# CAPEL MANOR COLLEGE, MOTTINGHAM CAMPUS

Planning Derogation  
January 2024

The document provides a comprehensive synopsis of the changes from the planning approved plan CMC-MOT-L101\_R2 to the current amended plan CMC-PRP-ZZ-00-DR-L-2500\_REVB

## WELCOME TERRACE

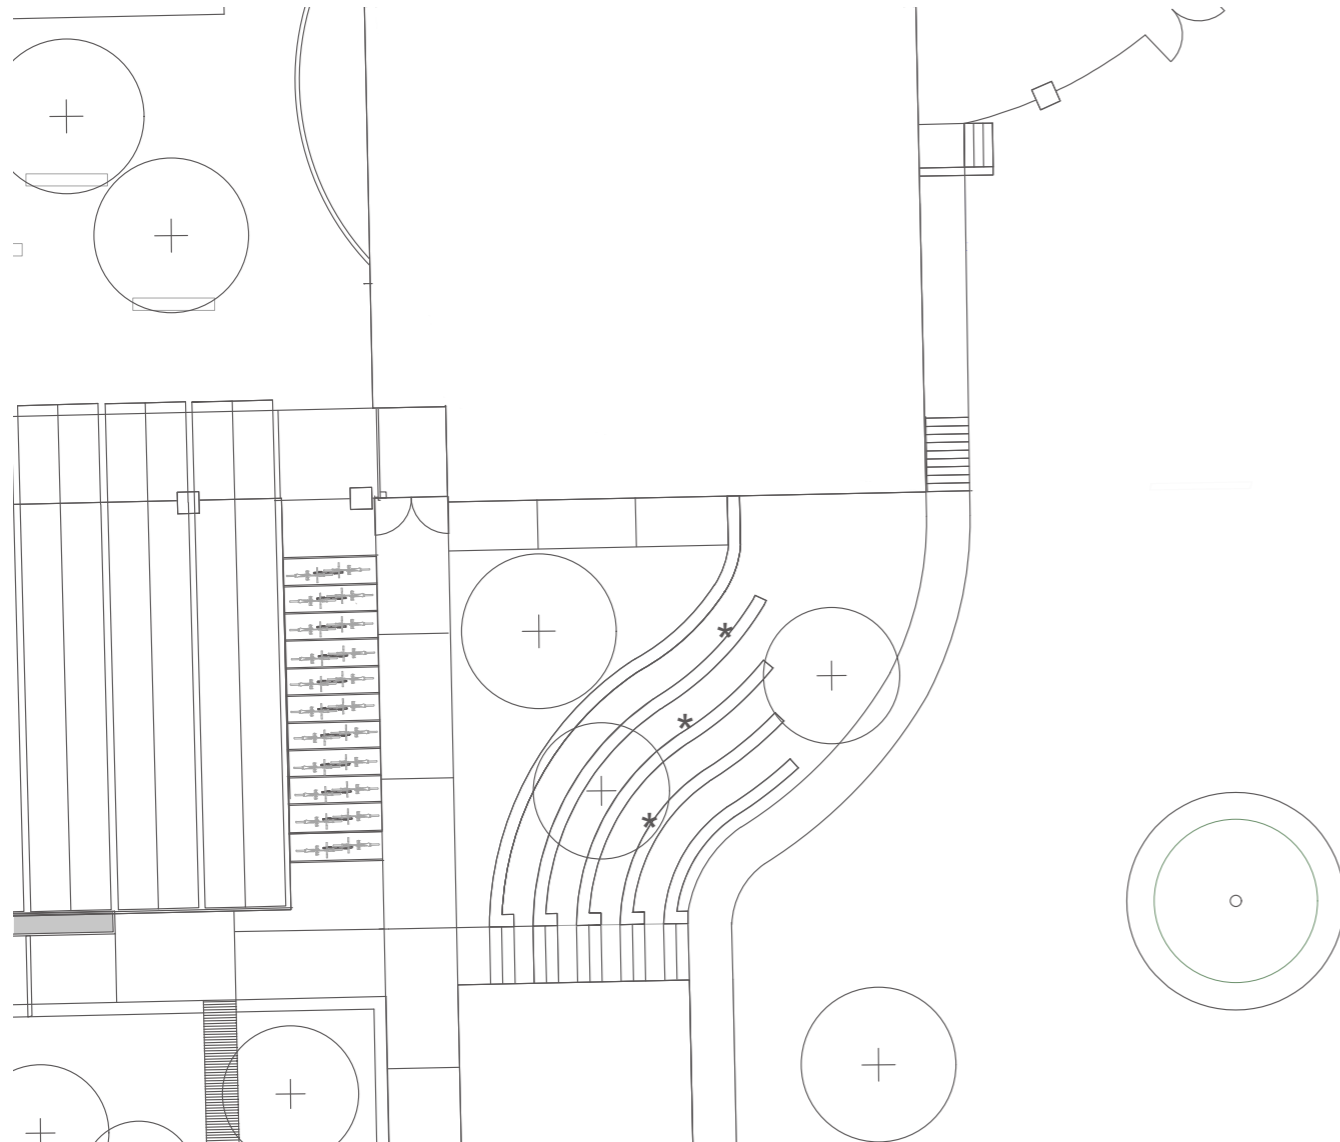
The Welcome Terrace has been reviewed to respond to the further development of the architecture, and to detail the proposed levels for the landscape design.

The 11 no. cycle stands have been moved to the opposite side of the greenhouse due to the proposed staircase leading from the Welcome Block to the Welcome Terrace.

A step-free access route has been proposed leading from the ground level to the top of the terraces to fully improve accessibility for the site and make the overall area more permeable

## CENTRAL COURTYARD

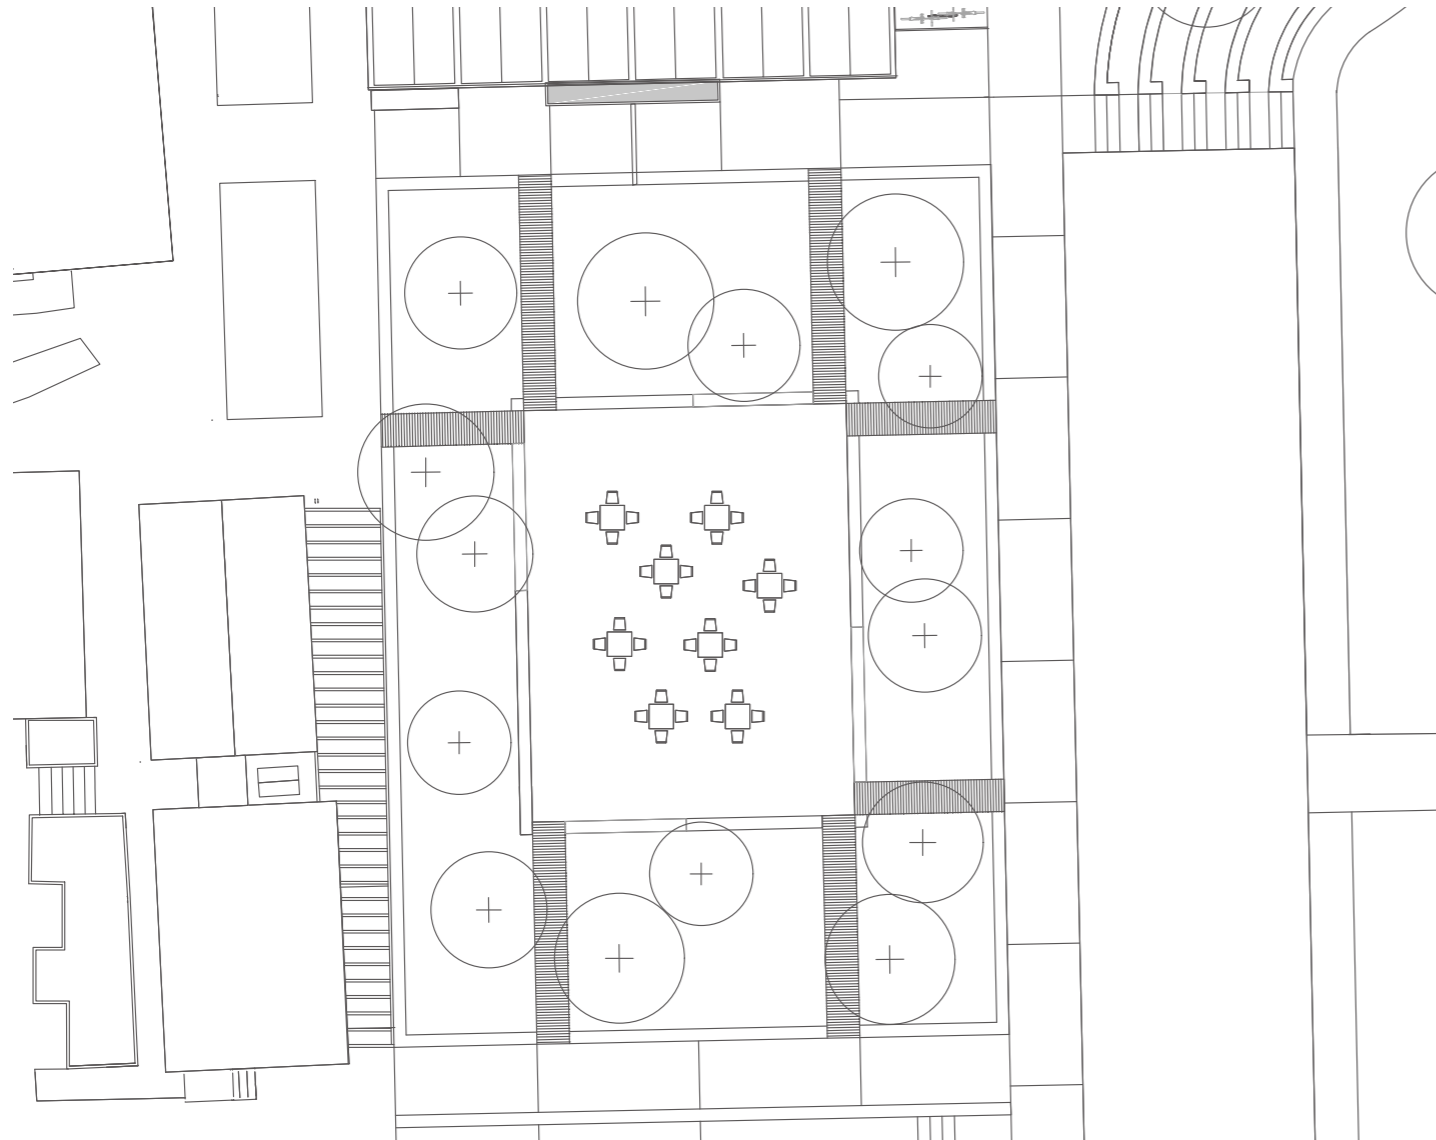
The proposed planting and seating in the Central Courtyard has been omitted in place of growing beds.

Given the removal of one greenhouse, PRP is proposing growing beds in its place. This will retain the green openness of the previous proposal, while also minimising the loss of opportunities for plant growing, and enable the students to engage in planting sessions.

## SOUTH OF THE TEACHING BLOCK

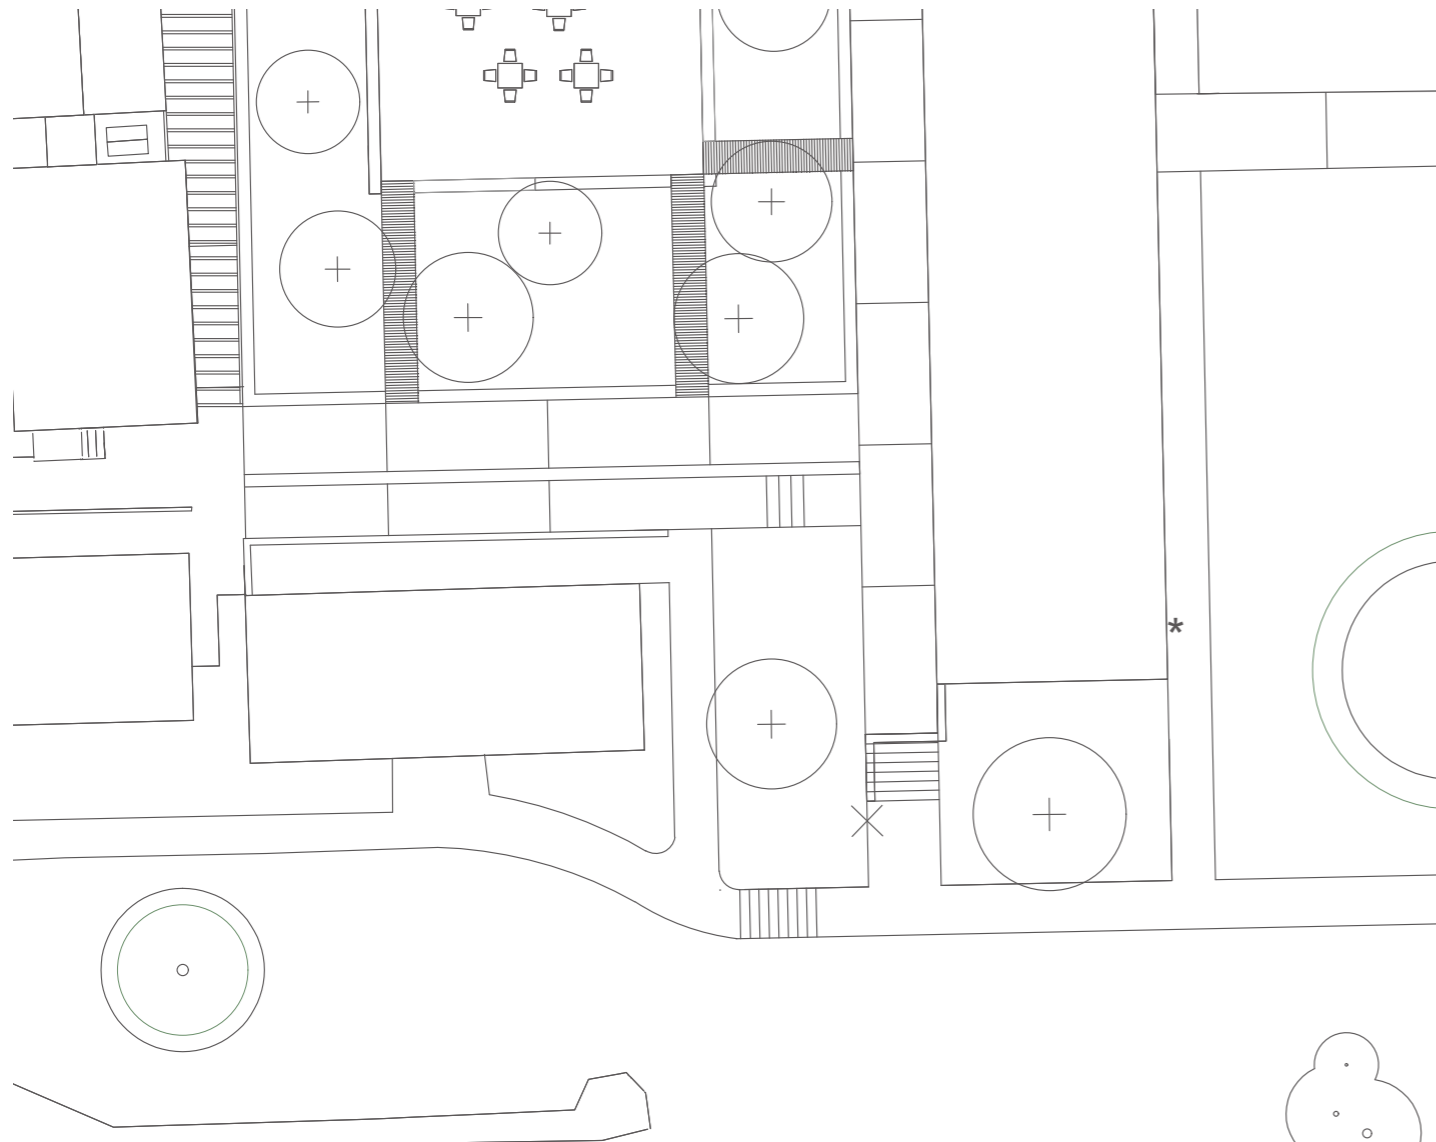
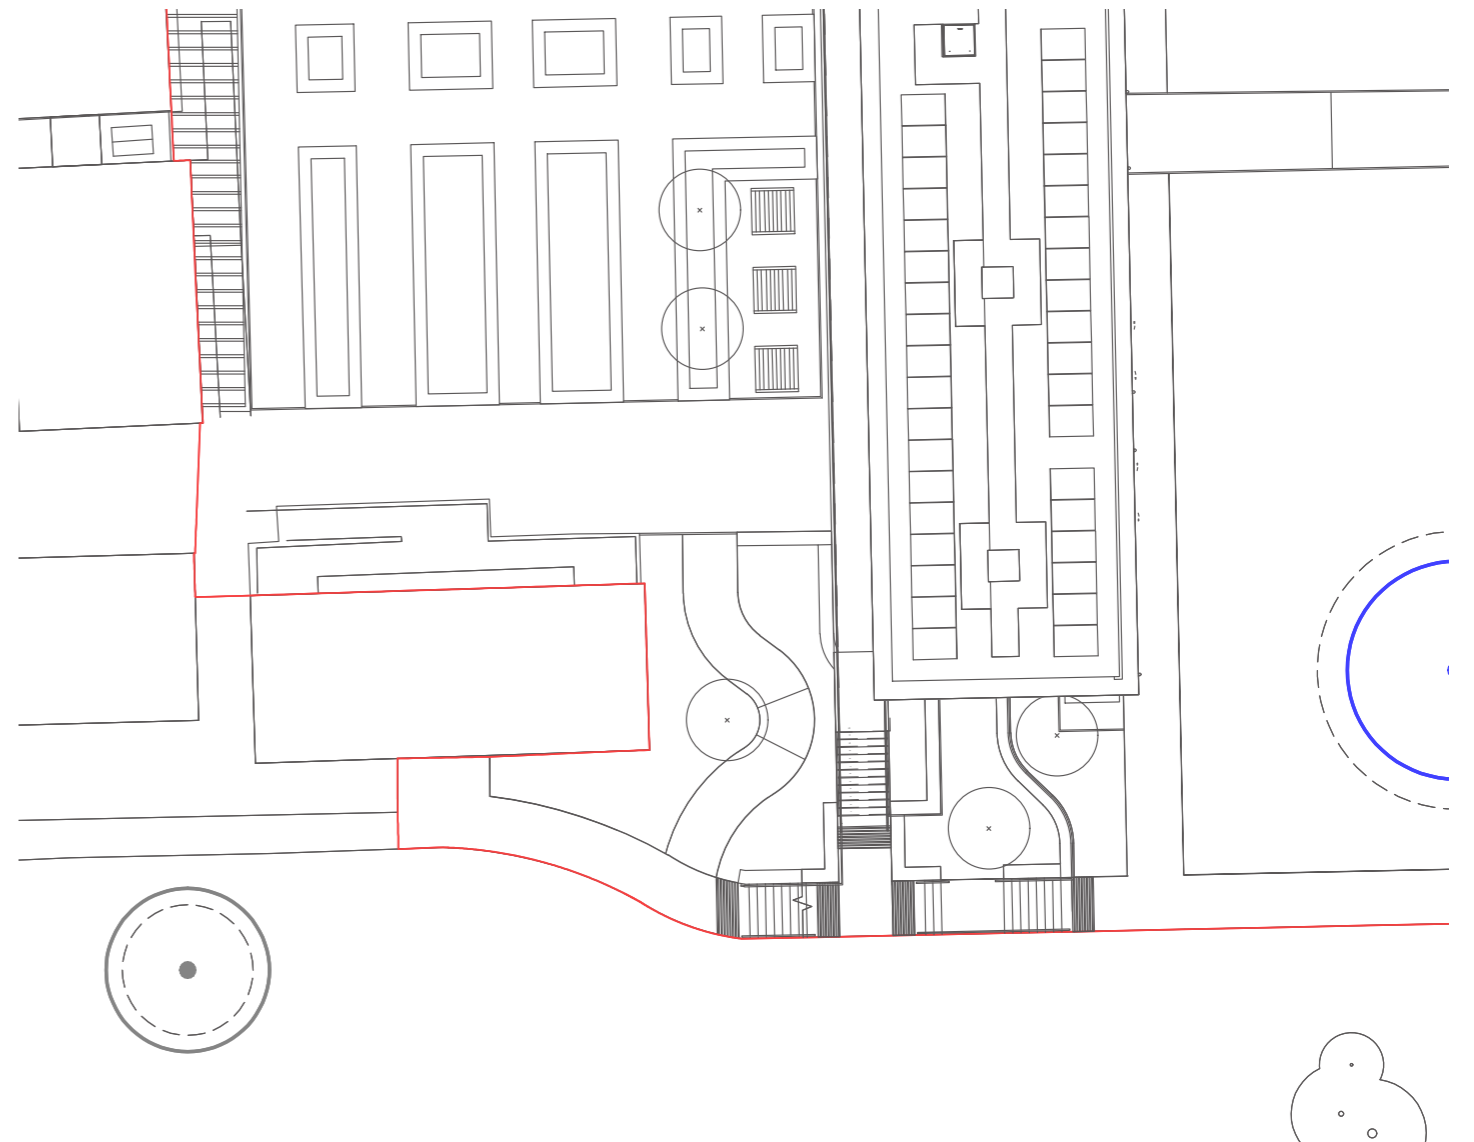
The area south of the Teaching Block has been reviewed to respond to the further development of the architecture, and to detail the proposed levels for the landscape design.

The path between the existing classrooms M6/M7 and the Teaching Block has also been reviewed to provide a more direct, step-free access to the south of classrooms M6/M7.
